**Report: TAB REPORT  
Function: Test, Adjust, & Balance  
Date: 03/05/2023**

## **01-23-23 CULVERS - RICHLAND CENTER, WI (REVIVE)**

**Issue Name :** RTU Humidity sensor wiring

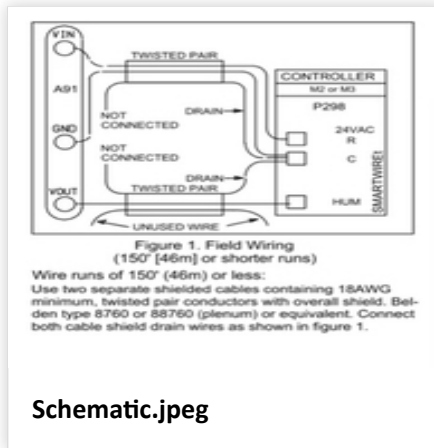
**Description :** Drain wires for humidity sensor are not connected. Recommend drain wires are connected per humidity sensor wiring schematic attached.

**Issue Name :** RTUs jumpered for occupancy.

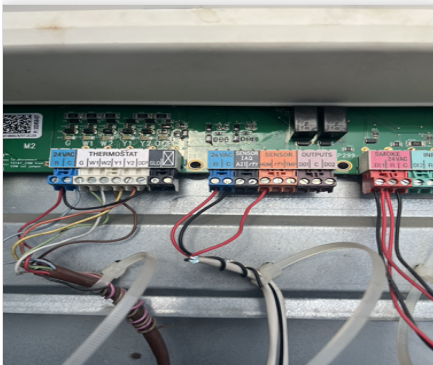
**Description :** Both RTU-1 and RTU-2 are jumpered for occupancy (wire from R to OCP). When OCP is energized, the outside air damper opens. Recommend the jumper is removed and a wire is run from OCP to each RTUs thermostat. This will allow the outside damper to modulate based on scheduled occupancy at the thermostat.
